HARTZELL PROPELLER LLC
ALERT SERVICE BULLETIN
HM-ASB-003
Beta Rod Nut/Safety Wire Inspection

- (1) Hartzell Propeller HM-(D,E)4N-3() Wing-In-Ground Effect lightweight turbine propellers are affected by this Alert Service Bulletin.

Safety Wire Interference
Figure 1

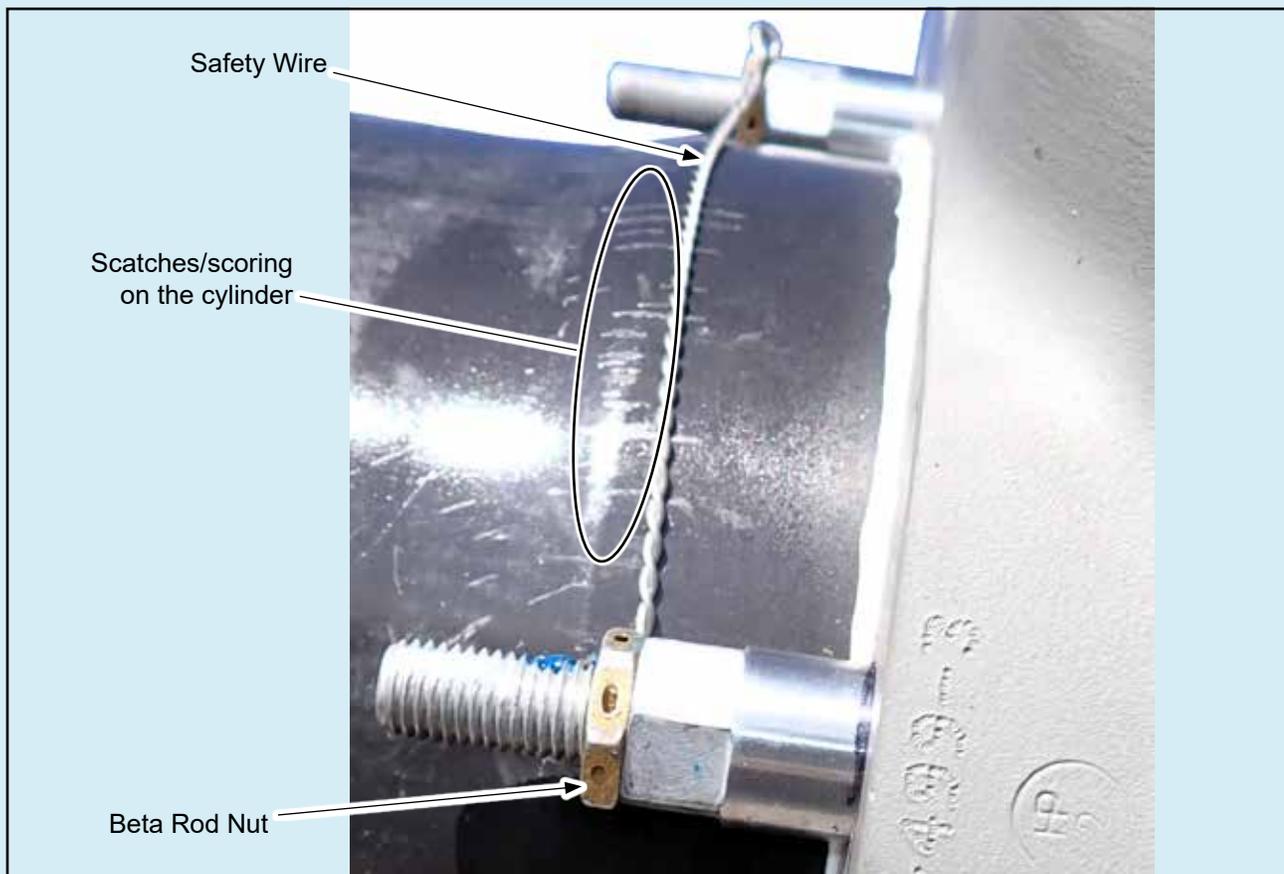
- (1) Hartzell Propeller LLC received information about an accident involving a propeller that went into uncommanded reverse during flight.
- (a) The accident investigation found safety wire securing the beta rod nuts and evidence of interference between the safety wire and the cylinder on the affected propeller. Refer to Figure 1.
- 1 Safety wire is **not** authorized for the beta rod nuts on affected propellers.

Beta Rod Nut Inspection
Figure 2

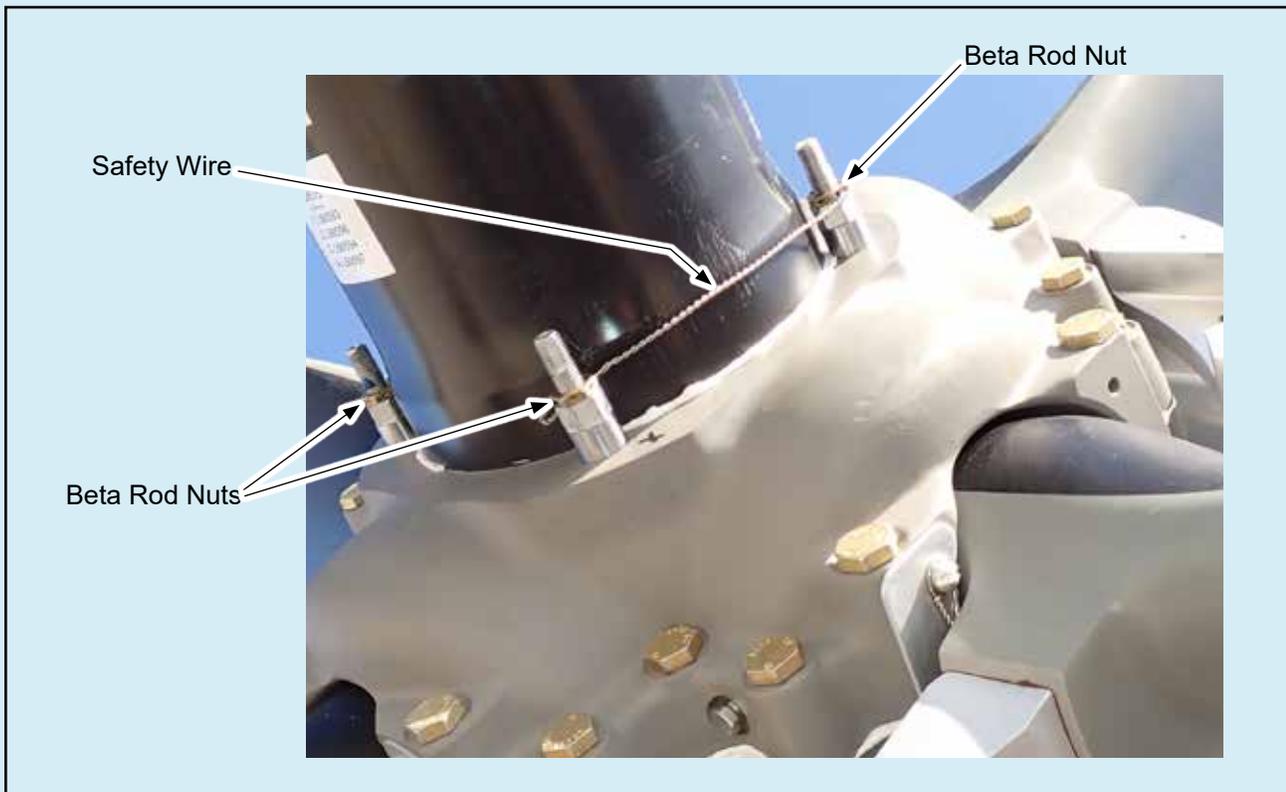
- (1) Using an appropriate light source, examine the fore-side beta rod nuts through the blade cutouts in the spinner dome. (Refer to Figure 2 - for clarity, the spinner dome is not shown)
 - (a) If there is safety wire on the beta rod nuts:
 - 1 Before further operation, remove the safety wire in accordance with the instructions in this Alert Service Bulletin.
 - (b) If there is no safety wire on the beta rod nuts:
 - 1 Make a record of this inspection in the propeller logbook indicating compliance with this Alert Service Bulletin.
 - 2 No further action is required.

Beta Rod Nut Inspections
Figure 3

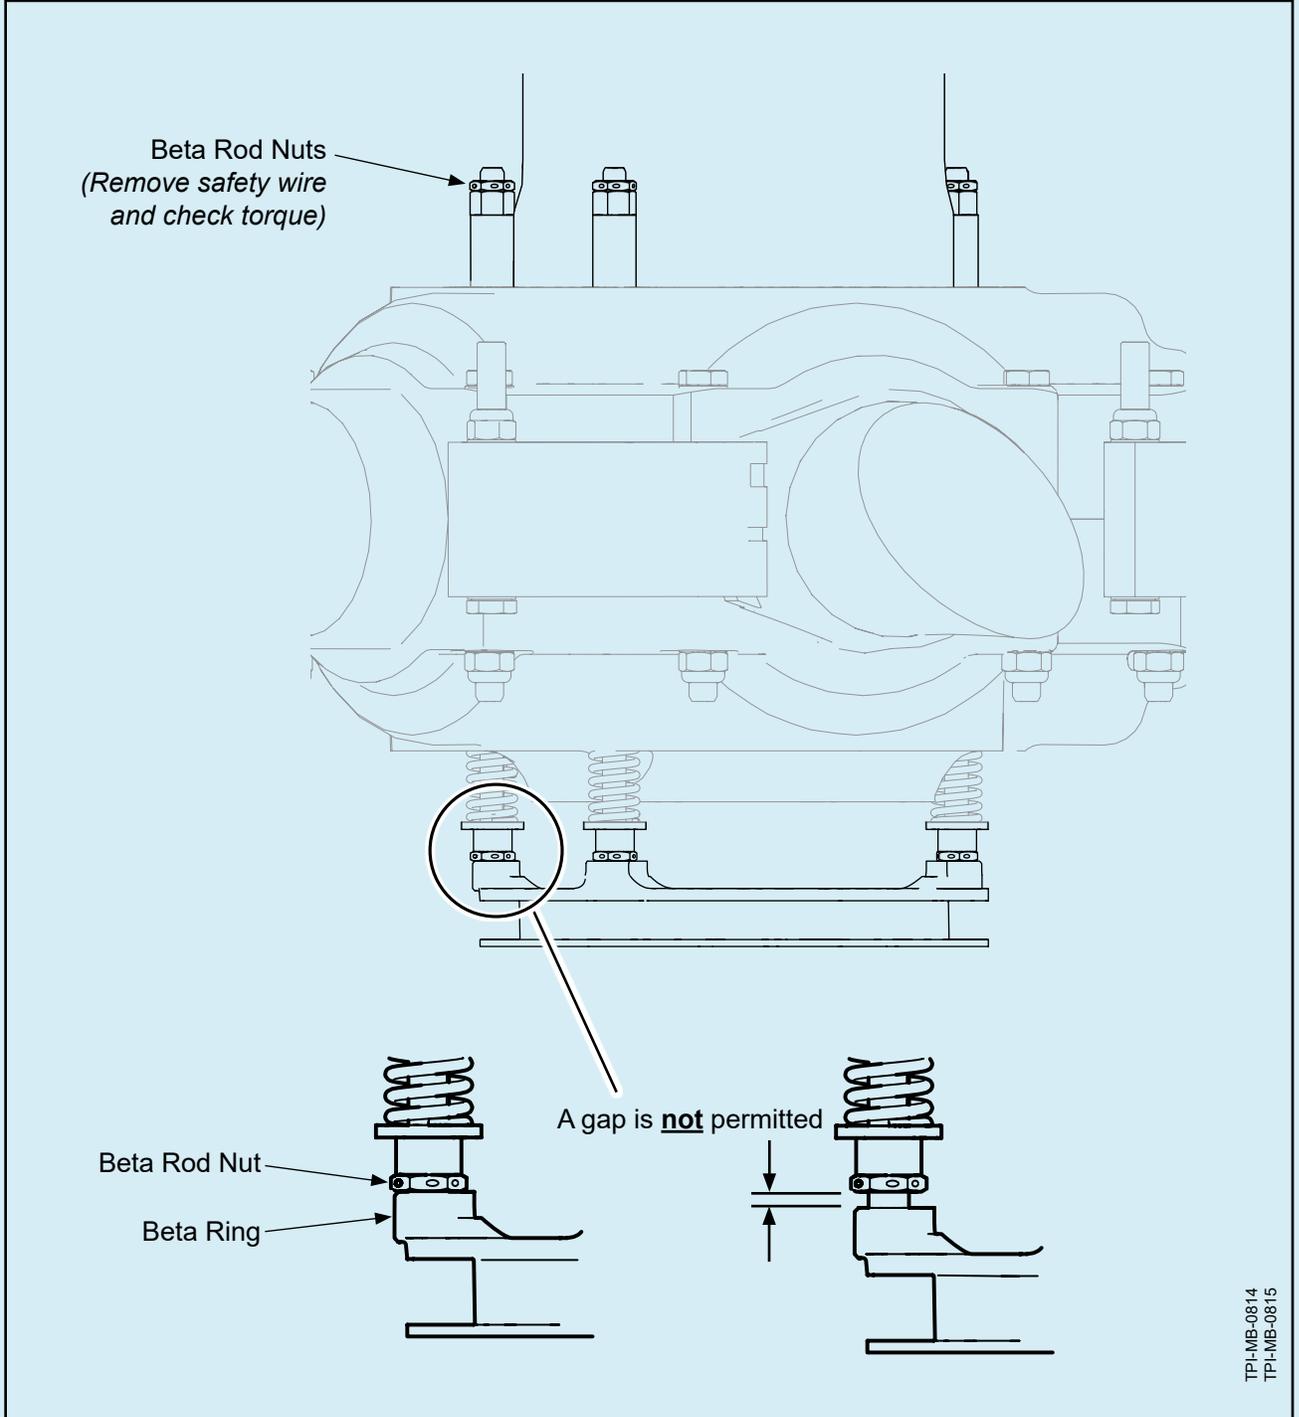
- (1) Remove the spinner dome in accordance with Hartzell Propeller Owner's Manual 350.
- (2) Remove the safety wire between the fore-side beta rod nuts.
- (3) Using a calibrated torque wrench, verify the torque on the fore-side beta rod nuts is 120 In-Lbs (13.5 N•m) \pm 10%.
- (4) Visually examine the aft-side beta rod nuts in accordance with Figure 3 and the following steps:
 - (a) If the beta rod nuts are flush against the beta ring, go to step (5).
 - (b) If there is a gap between the beta rod nut(s) and the beta ring:
 - 1 Remove the propeller in accordance with Hartzell Propeller Owner's Manual 350.
